File 1988-0019

Project Name: 7TH Day Adventist Church – Miller Sub.- 2554 F Road – Rezone & Final

MILLER SUBDIVISION SITE PLAN

REVIEW SHEET SUMMARY

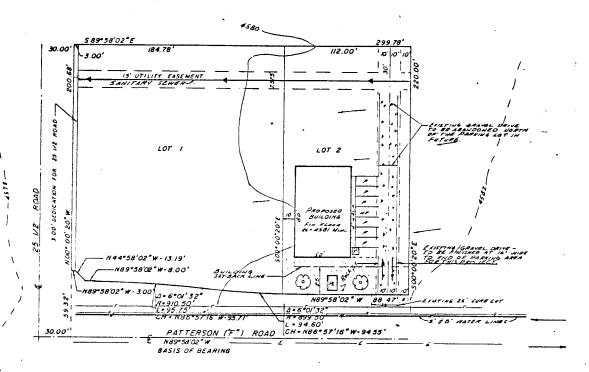
DATE REC. AGENCY COMMENTS NOTE: WRITTEN RESPONSE BY THE PETITIONER TO THE REVIEW COMMENTS IS REQUIRED A MINIMUM OF 48 HOURS PRIOR TO THE FIRST SCHEDULED PUBLIC HEARING. 05/20/88 City Engineer Entrance and exit arrows shown on driveway for lot 2 should be reversed. The driveway and proposed parking lot on lot 2 should be paved. Access to lot 1 should be from 25 1/2 Road for any future development. 05/09/88 Building Dept. I have discussed this project with Mr. Warren on a couple of occasions. He is aware of most of our requirements. A city licensed general contractor is required as well as building plans that are stamped by a Colorado licensed architect or professional engineer. 05/12/88 Mtn. Bell No objection 05/13/88 Public Service gas: electric: Request north ten (10) feet of lots 1 and 2 as utility easement. 05/16/88 Fire Dept. This office hasn't any objection to this subdivision as long as access for fire protection is coroved and adequate water is also provided for the same. If you have any questions, please call our office. Also, a fire flow will need to be done before any building can take place. 05/20/88 Ute Water No objection 05/24/88 Development Dept. There are several minor corrections which will need to be	Location:	2554 F Road Rezone	to PR-16 and minor subdivision

- 1) The 3.00' dedication to $25\frac{1}{2}$ Road is already existing; 33 feet of R.O.W. (total) has been dedicated.
- Various numbers in the description and dedication appear to be incorrect. Contact City Planning for details.

Since the requested/preferred zone is planned residential, the developer is encouraged to construct the 50'x80' building to appear somewhat residential in nature if possible. It is not clear whether the parking area will be paved or not. If not, anchored parking blocks should be installed to help delineate the parking stalls, as well as preventing automobiles from overhanging the 4' wide sidewalk next to the building. Rock is highly discouraged as a (widespread) ground cover and for landscape purposes. It tends to absorb much excess heat which can be damgaging to plants. Lawn or bark mulch is more appropriate and provides improved aesthetics. Please refer to the publication "Landscape Guidelines for Development in Grand Junction" available at City Planning. Any signage will require a
